# SECOND & WALL

210 WALL STREET

EARLY DESIGN GUIDANCE MEETING 2  
DOWNTOWN DESIGN REVIEW BOARD  
FEBRUARY 16, 2016  
DPD #3020932

Level 7 - Podium Rooftop Amenity Plan

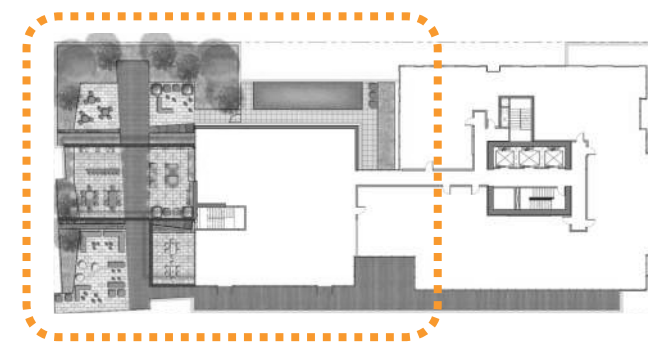
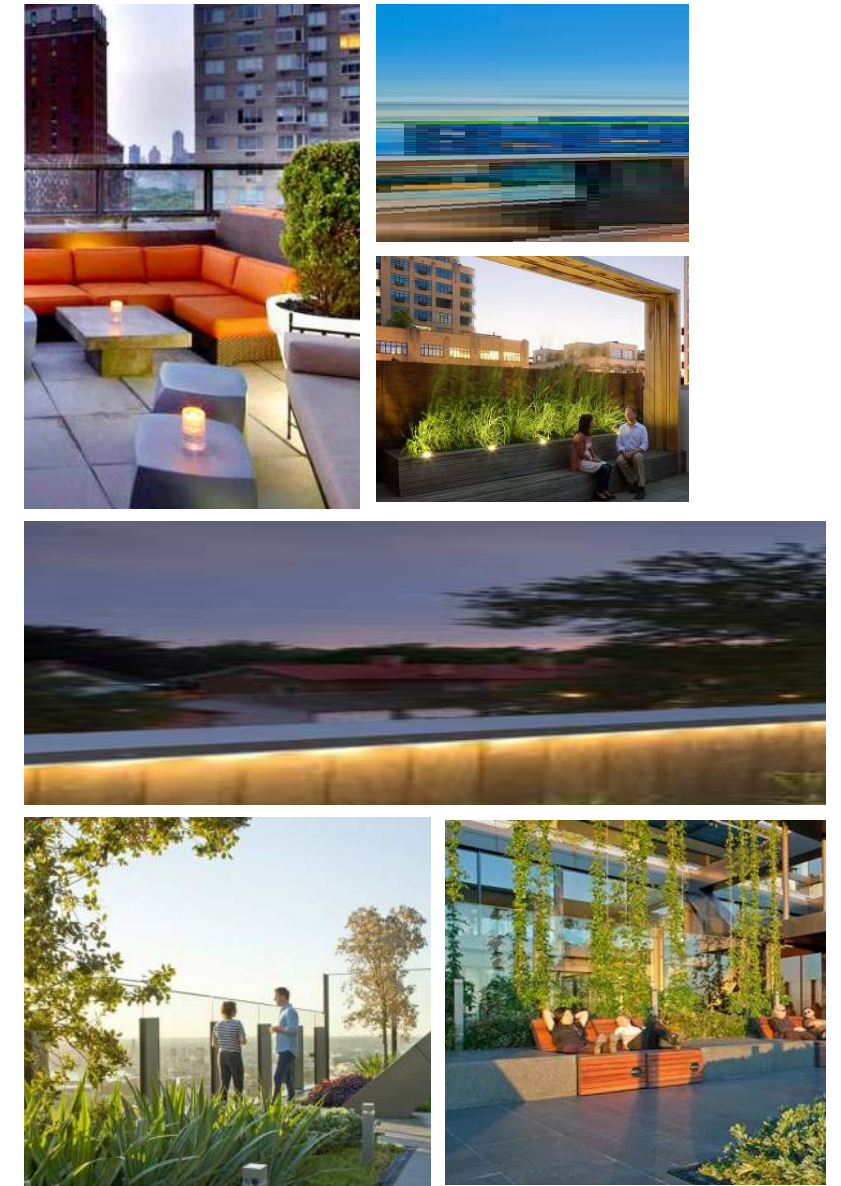
The Board expressed concern that the podium amenity broke up the roof too much. Perhaps it is more integrated with the tower.

Provide more detailed plans showing how the amenity space is integrated to the adjacent uses and rooftop spaces.

The amenity program is now incorporated into the new mid-level mass. By concentrating the mass into a more unified form, the remaining roof area is naturally divided into open space for larger groups to the north, and areas for smaller group activities to the west.

The amenity and roof access is connected to, but visually separate from, the dwelling units on level 7. Residents cross a perceived threshold as they move from private apartments to the common spaces.

Ground Floor Plan

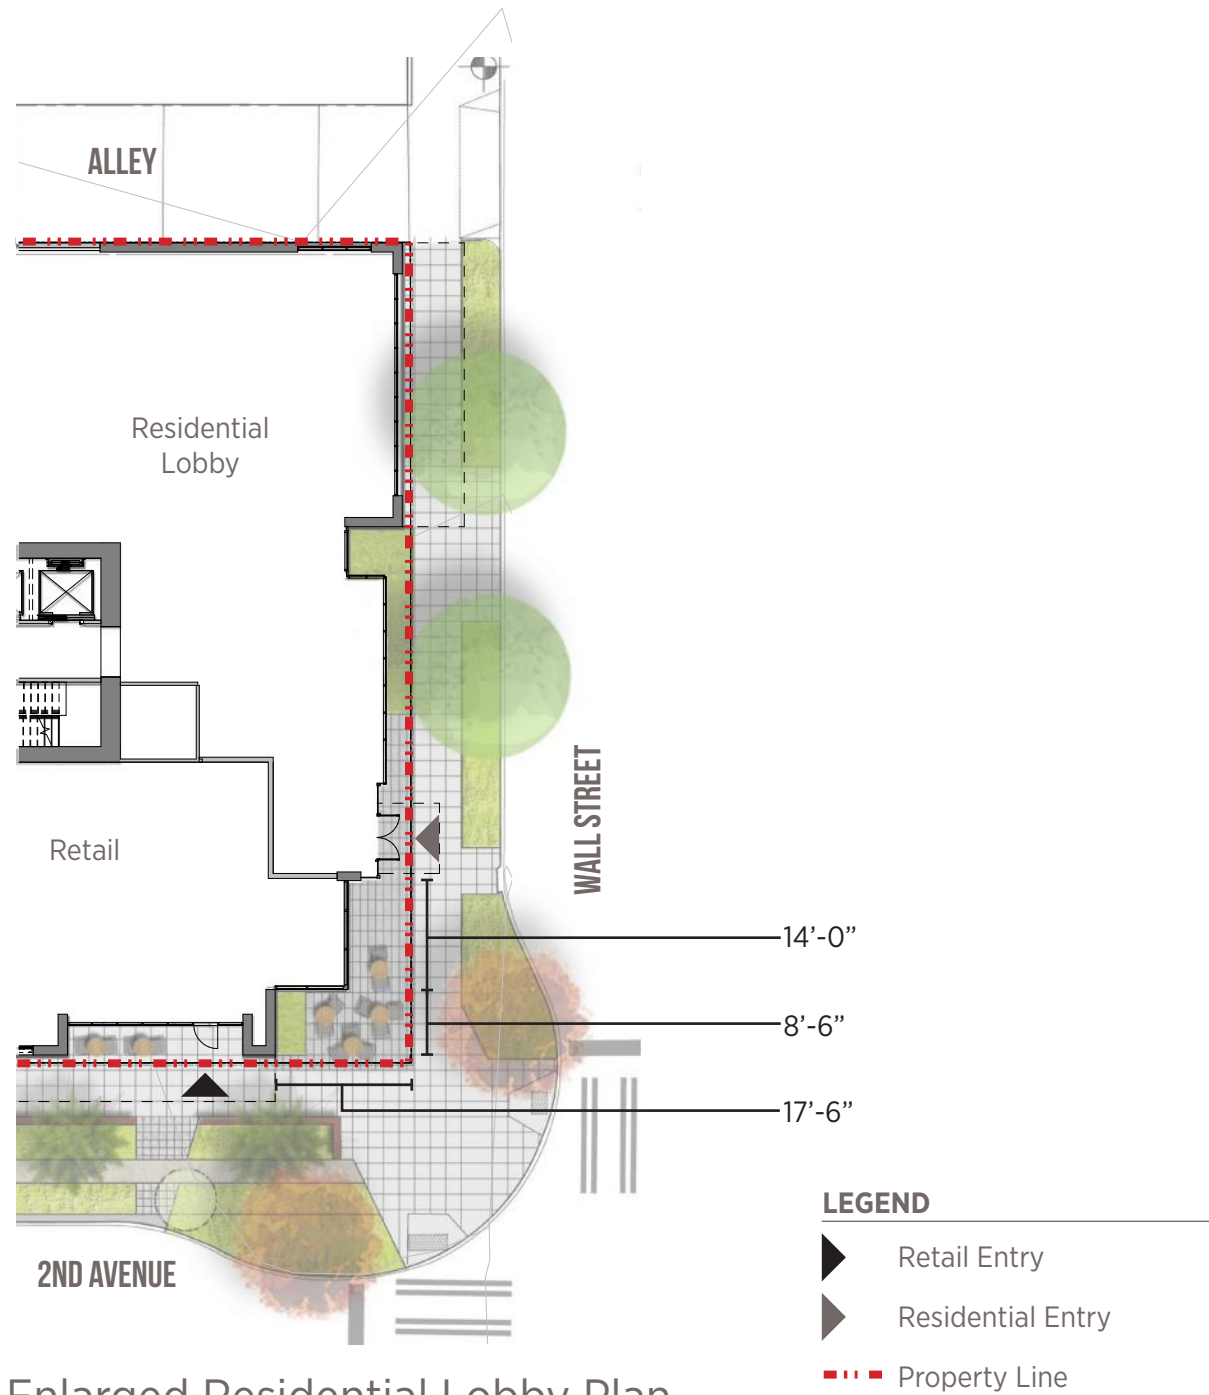
- The Board wants to see more articulation and variation at street-level, similar to the precedents shown on pg 29.
- The Board recommended recesses rather than the proposed projected retail bays.
- Explore place-making recesses at the street corners.

The updated podium design incorporates more defined modulation than was presented at the first EDG Meeting. Retail bays are expressed in a regular rhythm, and deeper recesses break up the long street frontage. The intent for the street level facade is to have high transparency, encouraging pedestrian interaction with the interior spaces

The storefront pattern changes at the corner of Vine Street, to respond to the different scale and activity of 2nd Avenue.

The building is now carved away from the lot line at the SW corner for a large place-making opportunity. The building angles at the NW corner for relief at the sidewalk.

Canopies, street furniture, and other elements define usable spaces.

Enlarged Residential Lobby Plan

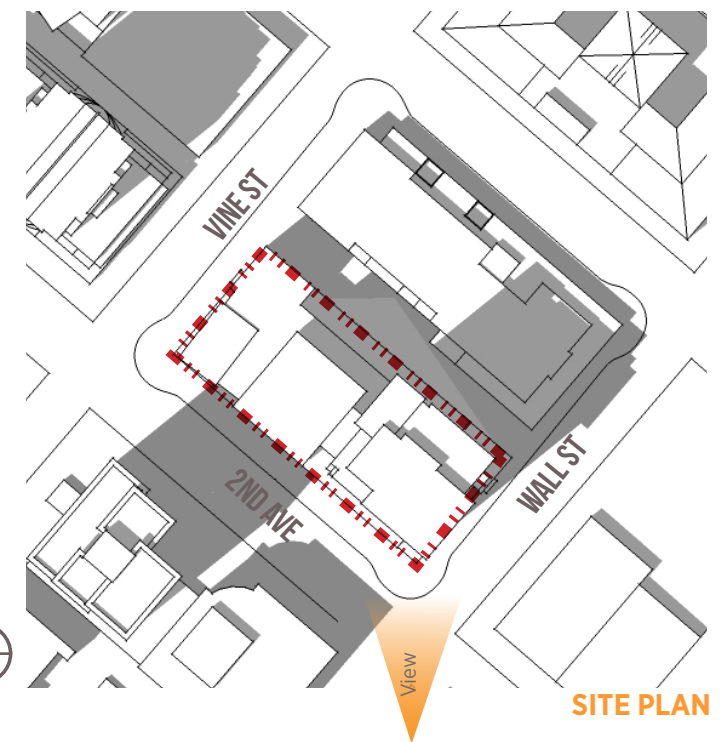
The Board requested that the residential lobby animate the street, be identifiable with legible contrast from retail storefronts, and not be subordinate to the commercial character of the “leasing” function.

The building entry has moved to the corner of 2nd Avenue and Wall Street. An open space in front of the lobby and an anchoring entry structure defines the entry as a different experience than a retail entry.

The open corner provides a stopping place, and allows the pedestrian to pause before continuing on, or entering the building.

## Enlarged Retail Plan

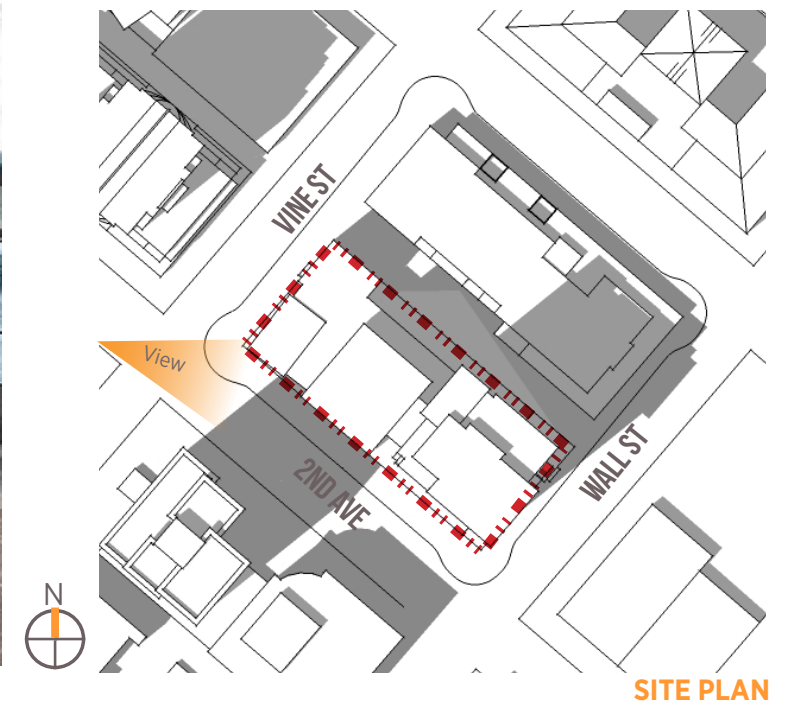
- The Board wants to see more articulation and variation at street-level
- The Board recommended recesses rather than the proposed projected retail bays.
- Explore place-making recesses at the street corners.

The podium design incorporates better defined modulation than was presented at the first EDG Meeting. Retail bays are expressed in a regular rhythm, and recesses break up the long street frontage.

Retail bays reduce scale at the corner of Vine Street, to respond to the condition of Vine, as it is different from the scale and activity of 2nd Avenue.
